Airways New Zealand Gisborne Airspace Amend Design Notes DRAFT v4 3 October 2019

This paper explains and defines the Airways version 4 requested changes to Gisborne airspace.

This version 4 differs from the earlier submitted version 2 with a small expansion of the requested 2500 ft CTA to the south of Gisborne. This is to facilitate a change to one of the planned new PBN arrival procedures.

Diagram 2 DRAFT amended GS CTR (the blue line) and 2500 ft CTA (the red line) version 4.
Note that the GS CTR upper limit is lowered to 2500 ft.

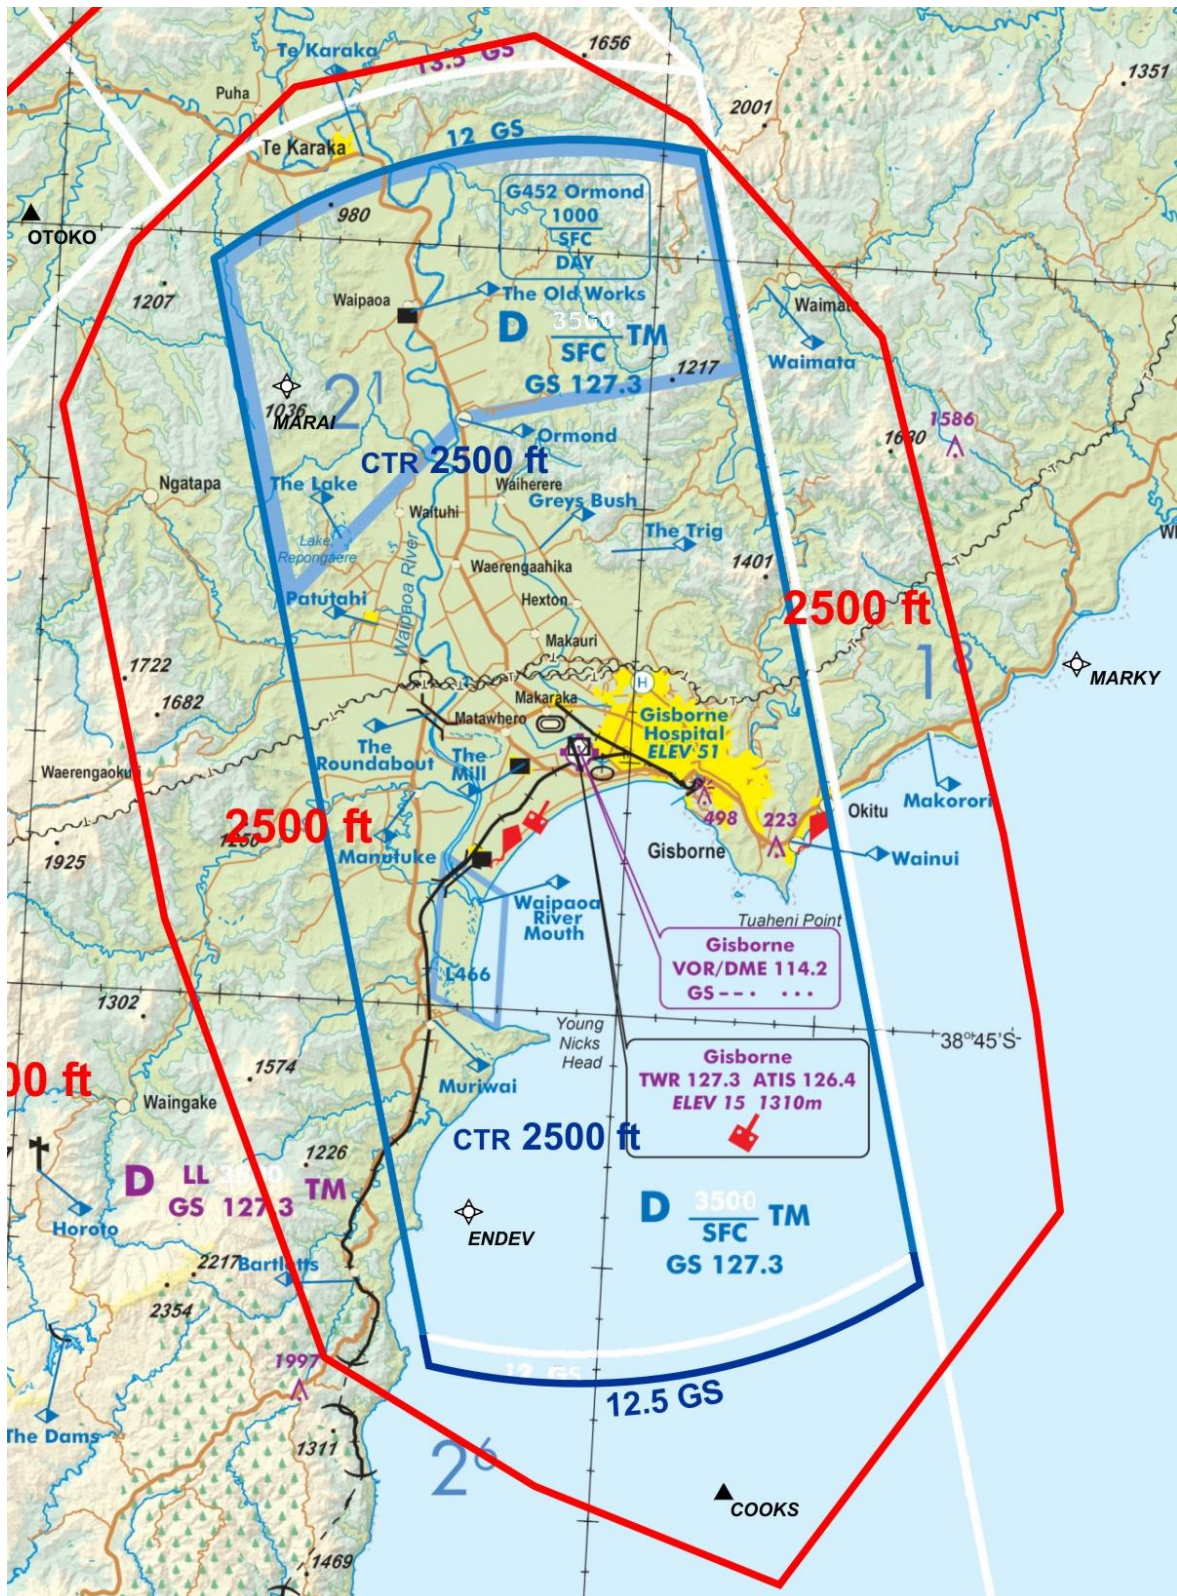
Diagram 2 below depicts the draft CTR v4. This is the same as the existing CTR except that the southern boundary has been moved out to 12.5 NM in order to contain the VOR/DME arc approach to RWY 32.

Note the CTR upper limit lowered to 2500 ft and the addition of a new CTA with lower limit 2500 ft.

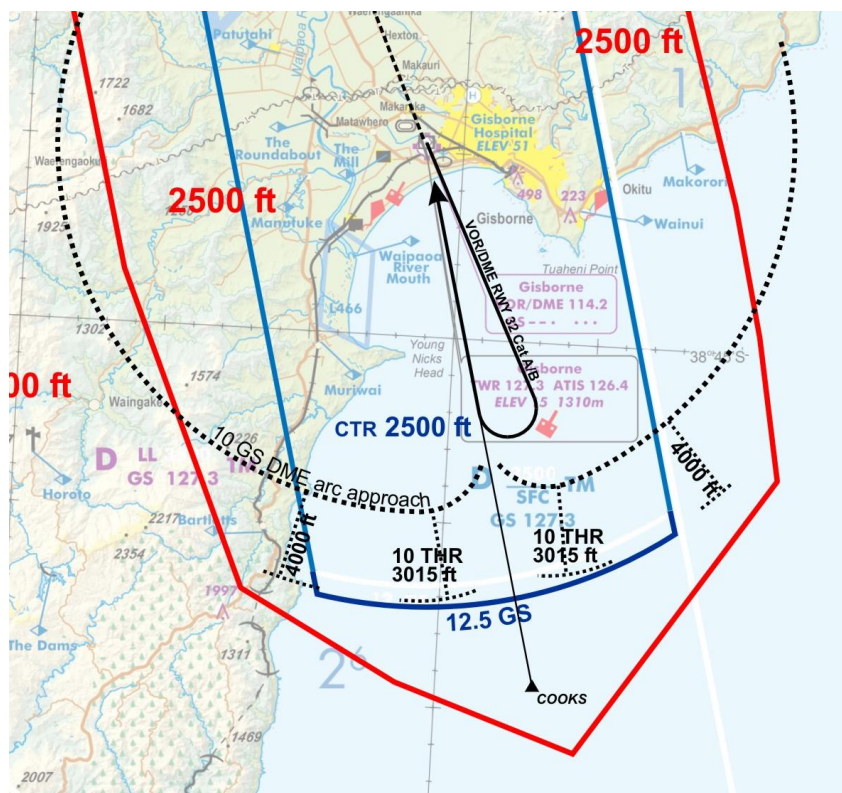
The CTR needs to be extended half a mile to the south to correctly contain the VOR/DME arc approach to RWY 32 as shown in Diagram 3 below. New boundary at 12.5 NM GS DME.

Diagram 4 Northern part of the GS CTR contains the arc approach to RWY 14 3000 ft and below.

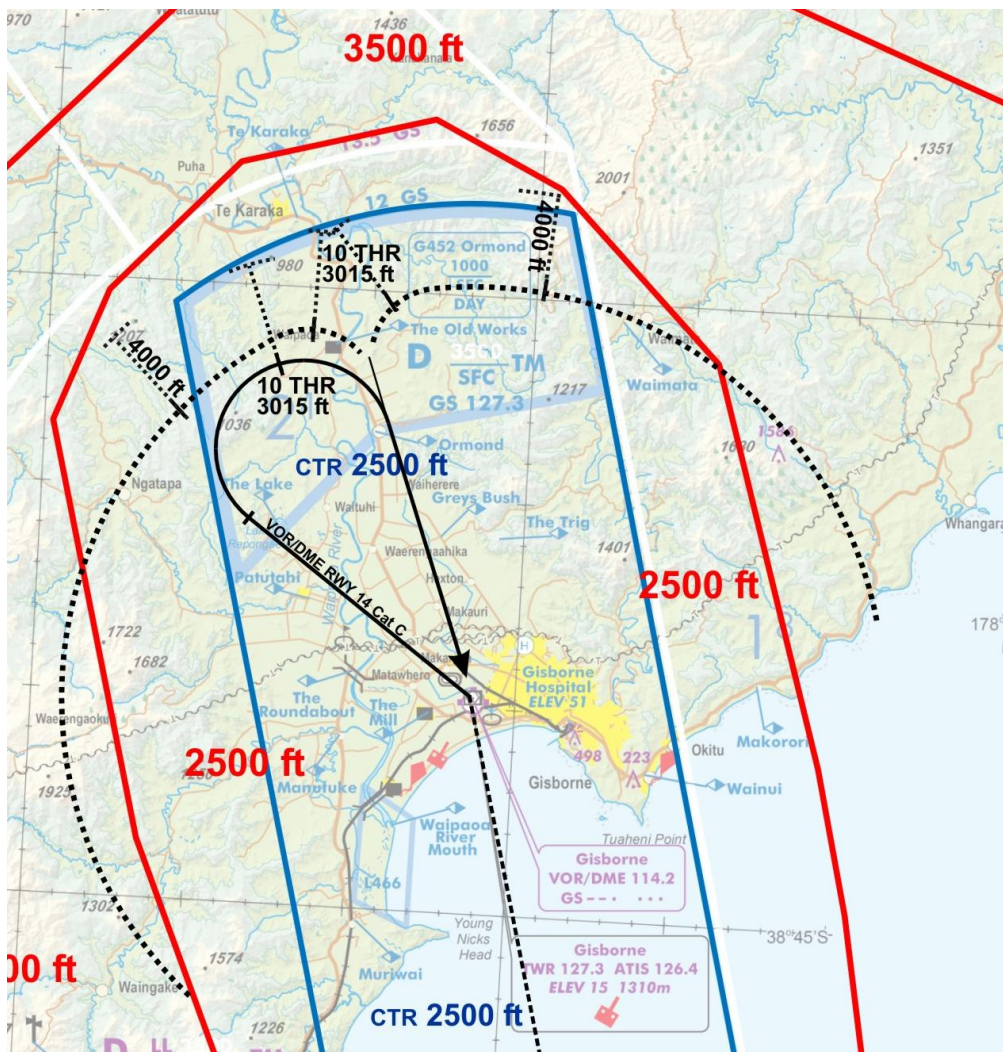
As shown in Diagram 4 below, the VOR/DME arc approach to RWY 14 3000 ft and below just fits within the northern part of the CTR with the new CTA 2500 ft encompassing the arc for the portions below 4000 ft.

Diagram 5 Northern part of the GS CTR with existing GAA G452 (SFC to 1000 ft) and the planned new PBN RNAV approach to RWY 14.

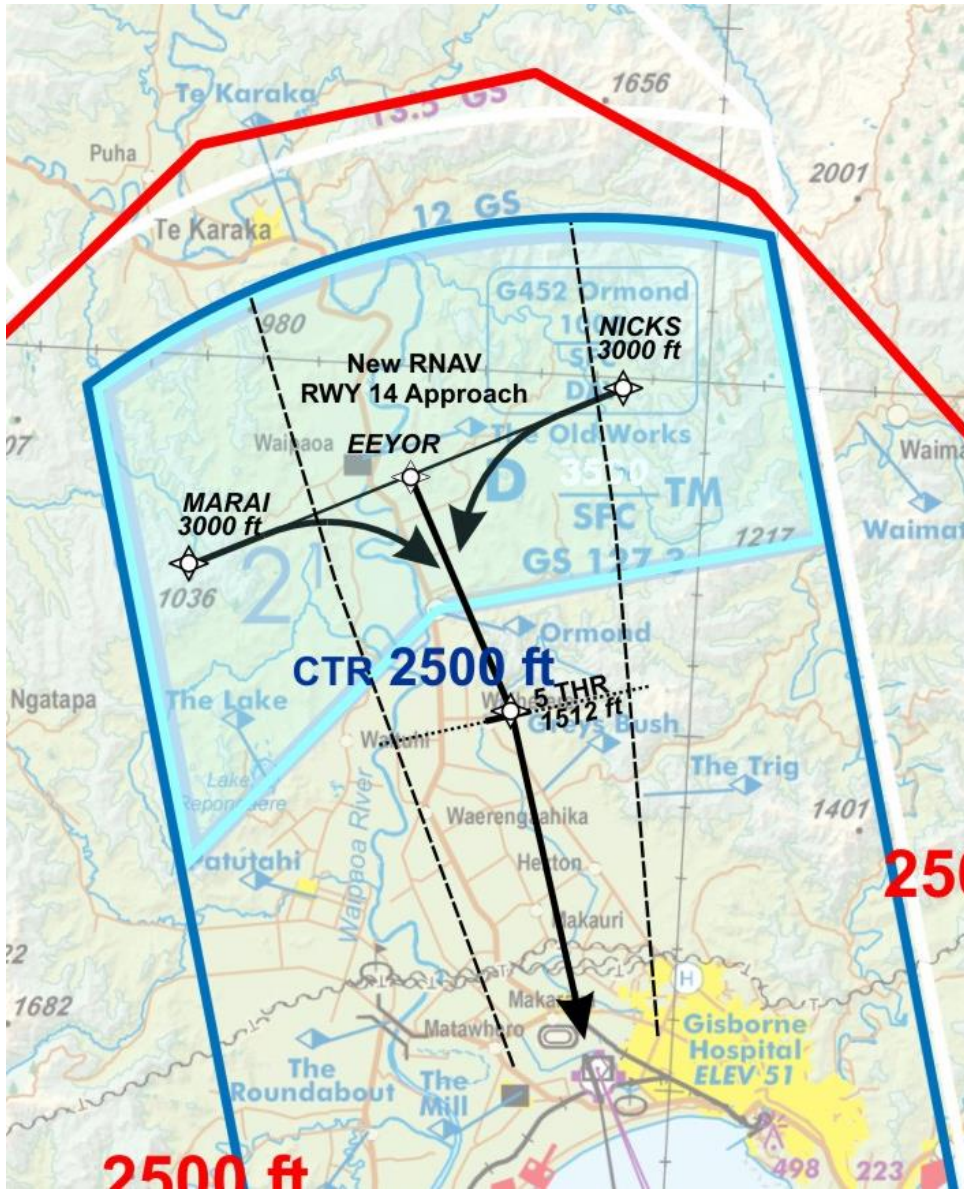
The Airways proposal includes retention of existing GAA G452 Ormond – our understanding being that it does still get used.

Applicable AIPNZ approach and departure charts for NZGS need to include depiction of this GAA.

Diagram 8 DRAFT amended GS CTA to the north of Gisborne with new PBN departures depicted along with profile level checkmarks. Profile being 300 ft/NM gradient from runway upwind threshold.

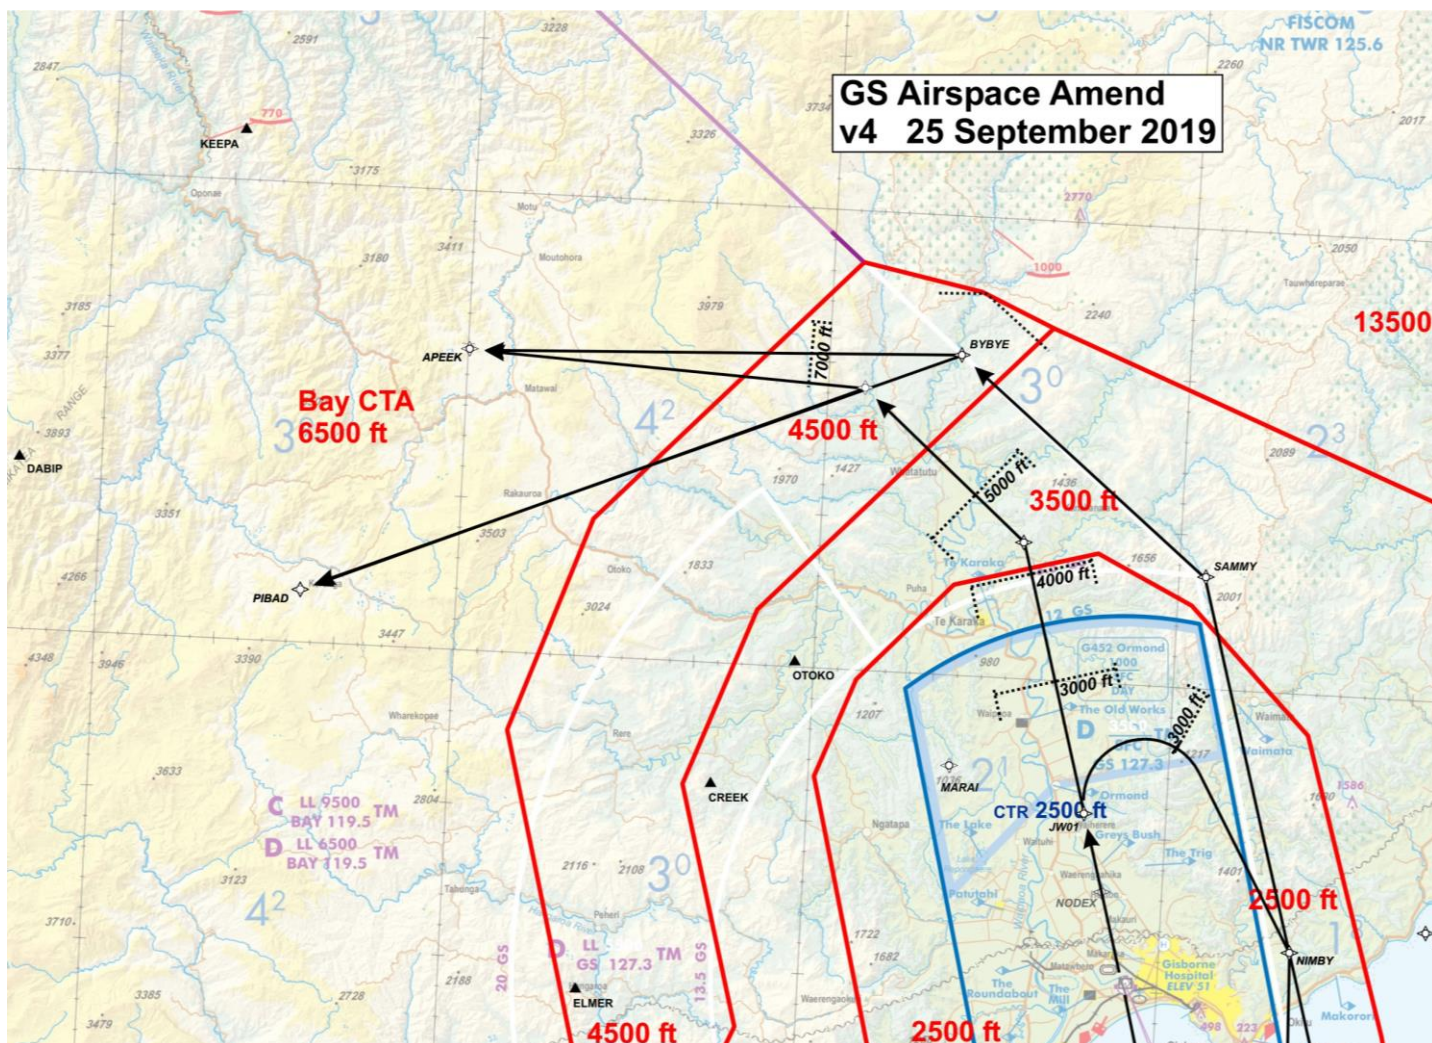
Diagram 8 below depicts the draft CTA v4 to the north of Gisborne. The planned new PBN departures off RWYs 14 and 32 to the north are depicted along with checkmarks showing the airspace policy profile (300 ft/NM) levels at various points. The profile of the departures, including their lateral buffer, must always be at least 500 ft above the lower limit of the CTA (e.g. cross into a CTA LL 6500 ft at 7000 ft or above). A portion of the 2 NM lateral buffer is depicted northeast of new waypoint 'BYBYE' – that buffer determining the location of the CTA boundary in that area.

Diagram 9 DRAFT amended GS CTA to the north of Gisborne with new PBN arrivals depicted along with profile level checkmarks.

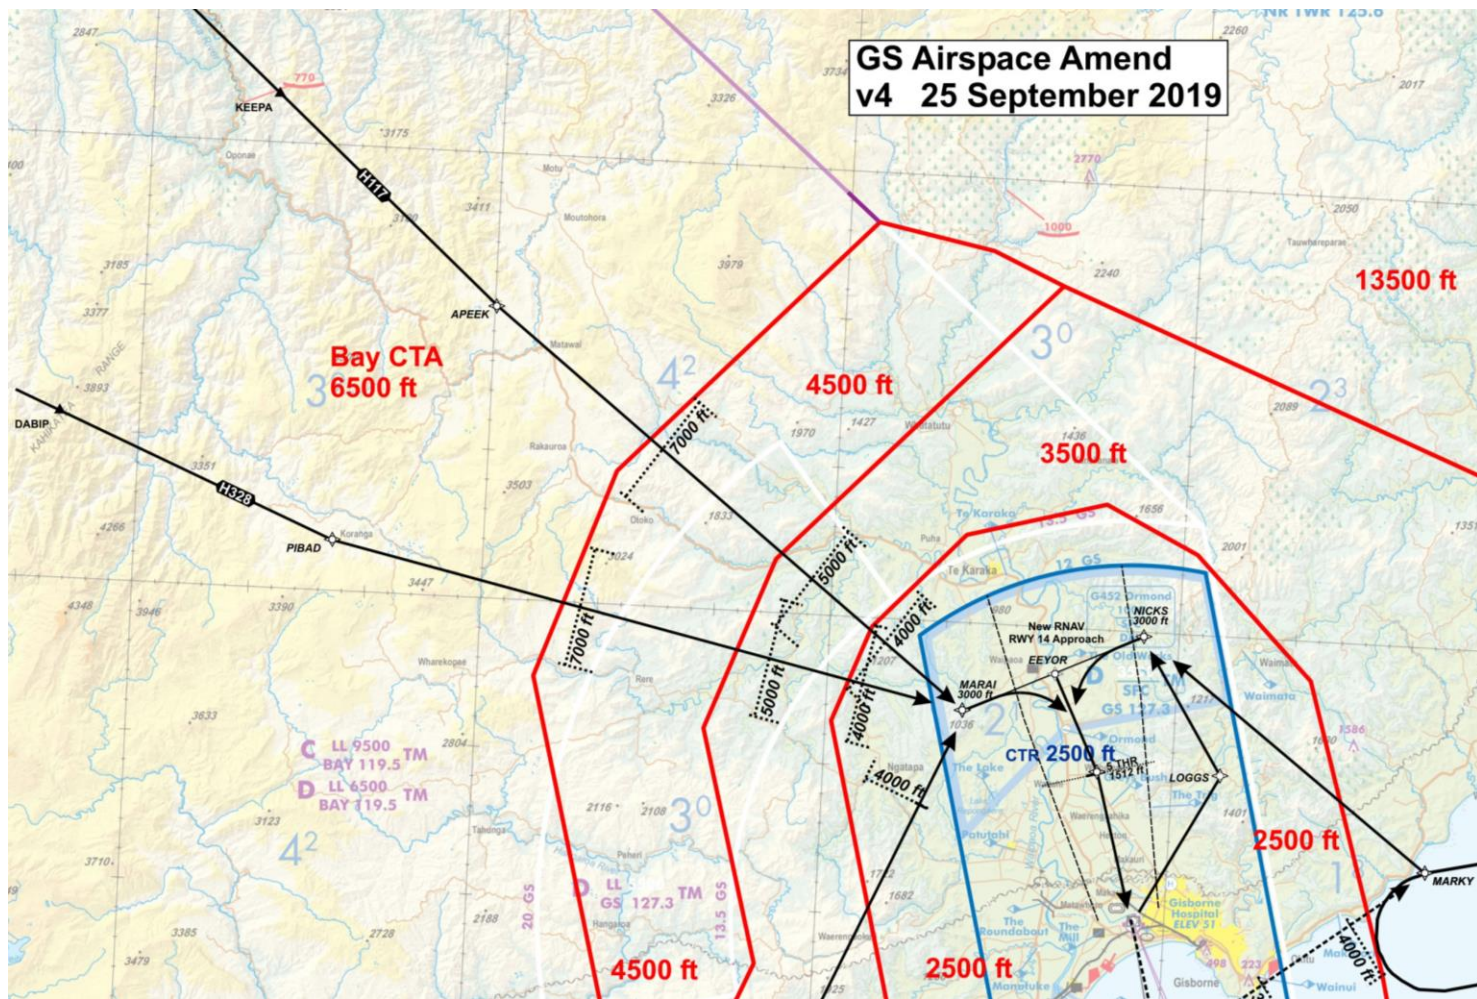
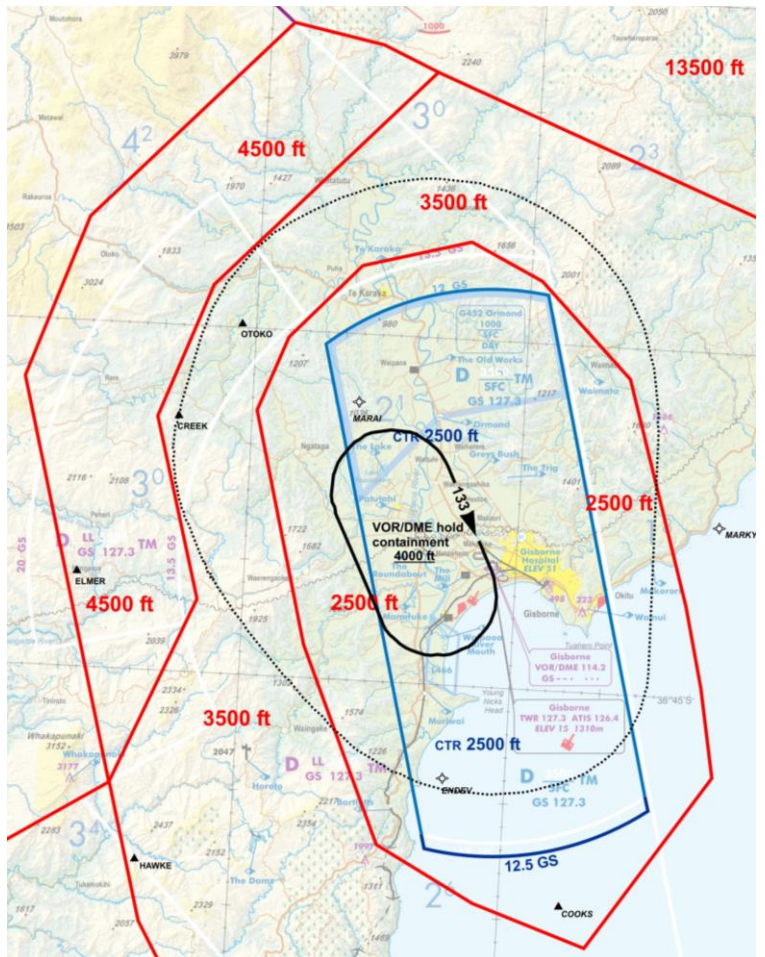
The planned new PBN arrivals to RWY 14 from the north-west also determine the location of the CTA boundaries as shown on Diagram 9 below. Again, a 300 ft/NM profile is used – this time based on the aircraft being at 3000 ft at the start of the T-Bar for the approach.

Diagram 10 DRAFT amended GS CTA to the north of Gisborne with the protection area (the black dotted line) for the VOR 133 holding pattern depicted.

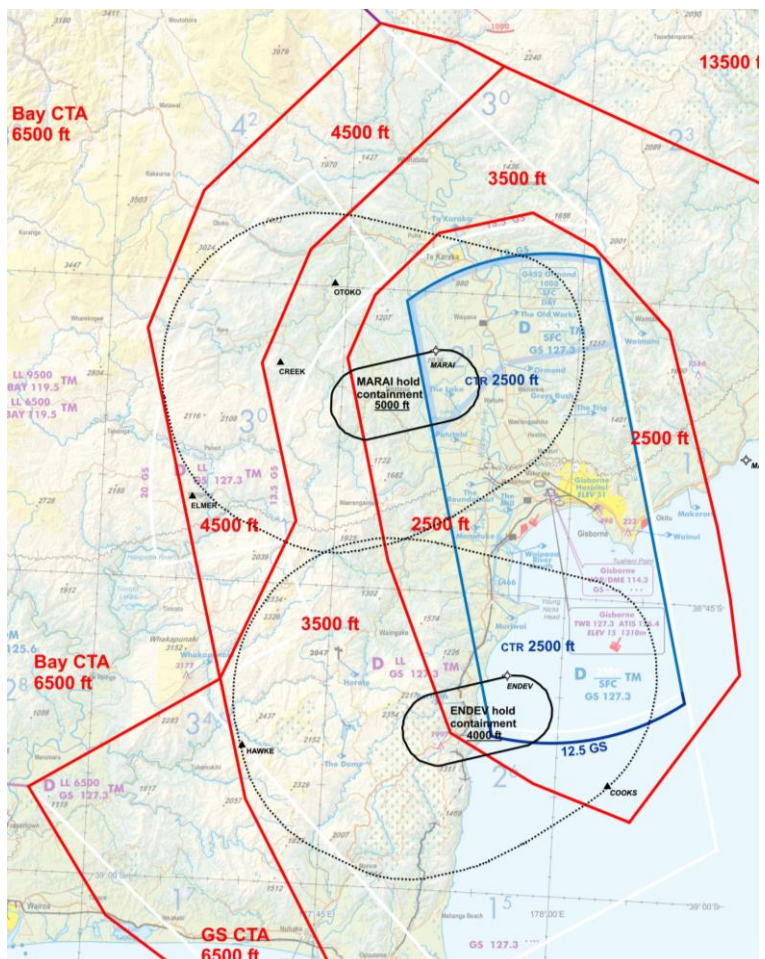
The containment area for the overhead VOR 133 holding pattern determines the extent of the 3500 ft CTA to the north-west of Gisborne. This holding pattern is contained at 4000 ft and above.

Diagram 12 DRAFT amended GS CTR and CTA with existing NICK THREE and CRAY THREE departures amended for correct containment.

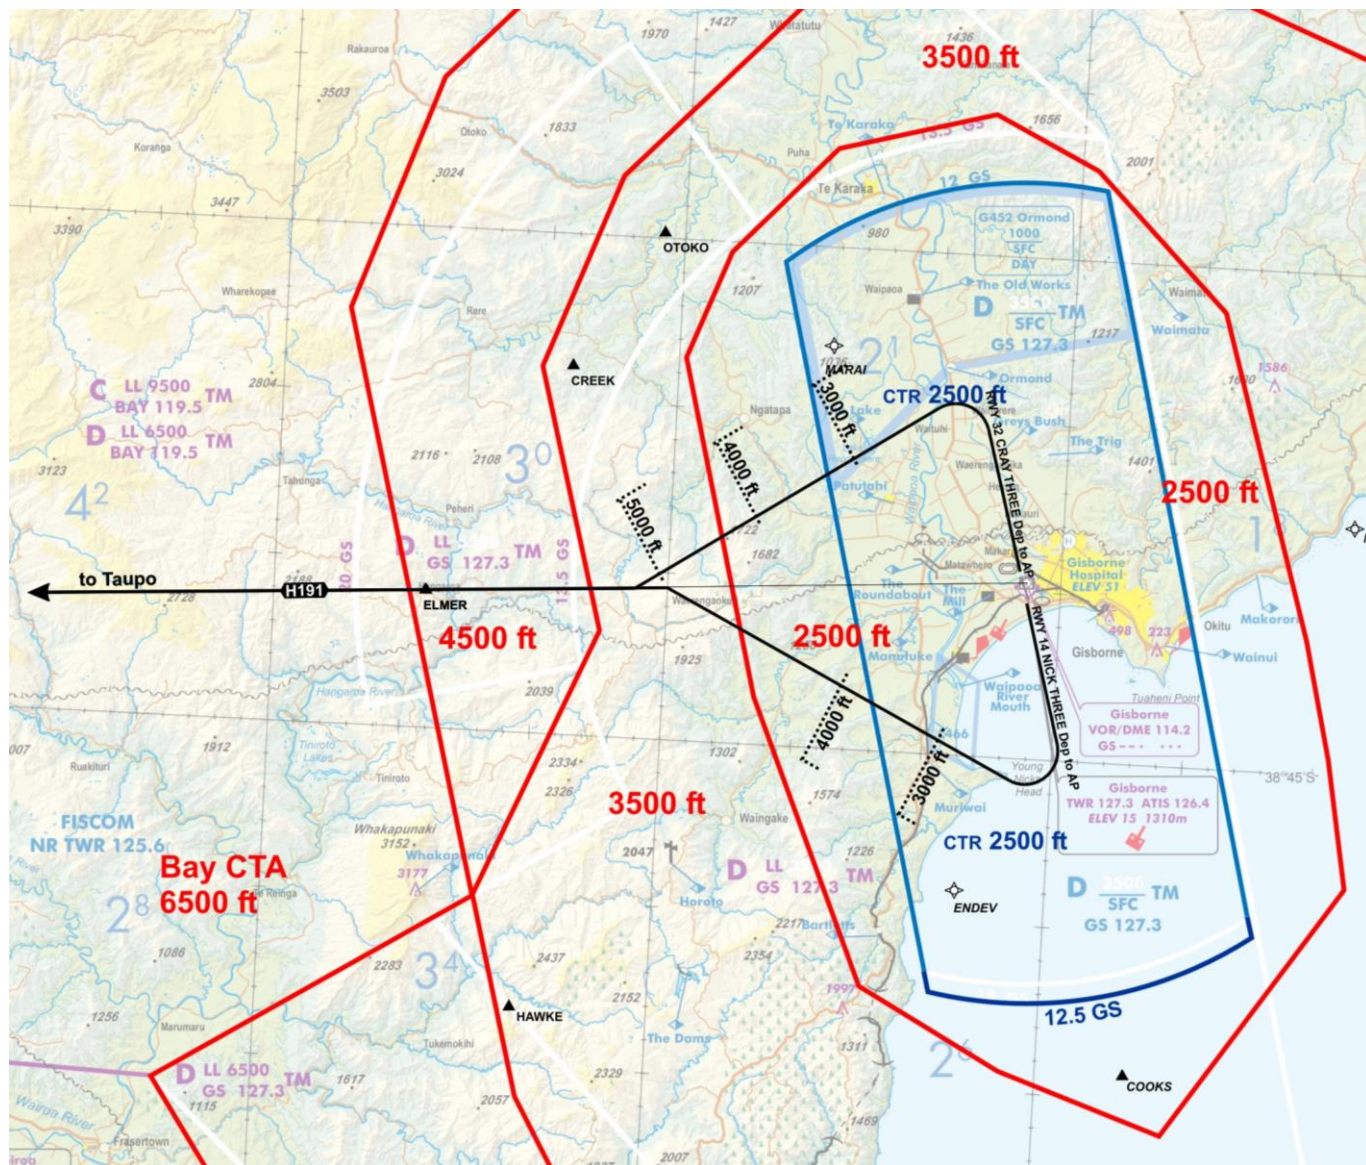
The existing NICK THREE and CRAY THREE departures need to be amended or replaced for correct airspace containment. Extending the runway centreline tracking until a higher minimum turn level (likely 1500 ft – 1800 ft) would provide for containment of the departures including their lateral buffer areas.
